TRIBAL EXECUTIVE COMMITTEE

January 5, 2023

Re: Nez Perce Tribe's Comments on the Stibnite Gold Project Supplemental Draft Environmental Impact Statement

Chart 3. Rates of Return for Selected Domestic Nonfinancial Industry Groups, 1999-2018

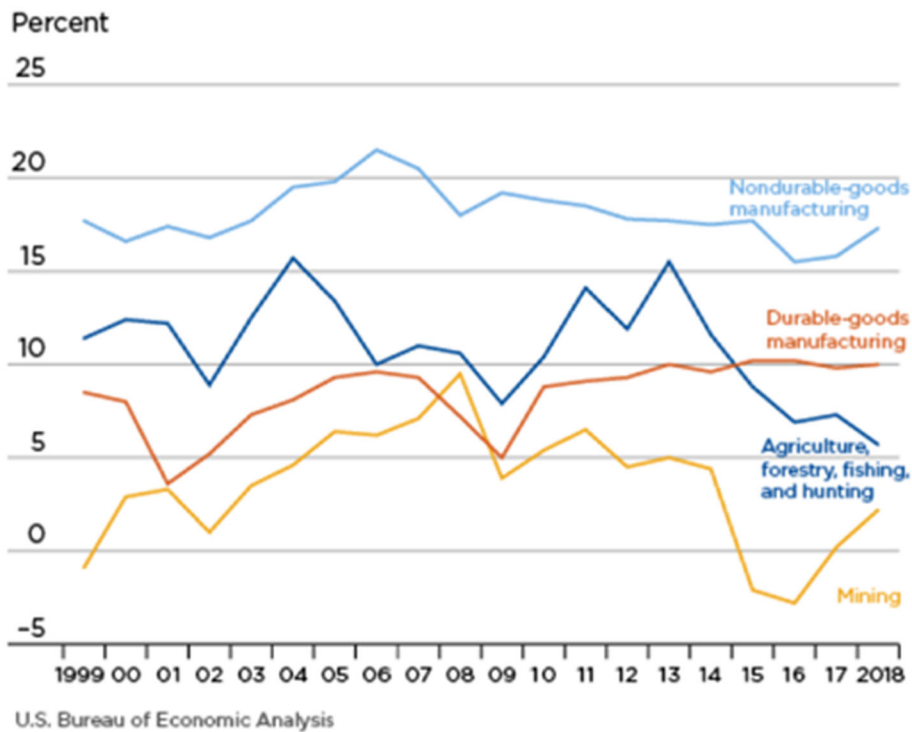
For an alternative to be economically feasible, the standard should not be whether the alternative retains the present projected profitability, but instead what is practical or reasonable. The following figure⁸⁴ (Chart 3) shows the rate of return for the United States domestic mining industry as well as other industry groups for the period 1999-2018. As suggested by the figure, none other than nondurable-goods manufacturing have consistently achieved a rate or return of 19.3%, and the mining industry's rate or return has ranged from less than zero to a high of below 10%. Therefore, it might be reasonable for an alternative to be economical provided the proponent achieves a rate of return of 10%. This would then be the standard upon which to measure the economic feasibility of a given alternative. By performing a cash flow analysis similar to that contained in the prefeasibility study but adding capital and operating costs, an evaluation can be made as to actual potential economic impacts.

The SDEIS and supporting AECOM 2020 Stibnite Gold Project EIS Draft Alternatives Considered, Carried Forward, or Eliminated from Further Study document should have provided a definition of technical and economic feasibility; and the rationale of each alternative with respect to technical and/or economic feasibility should have been evaluated and considered therein. The basis for economic feasibility should consider what is typical for the mining industry and a range
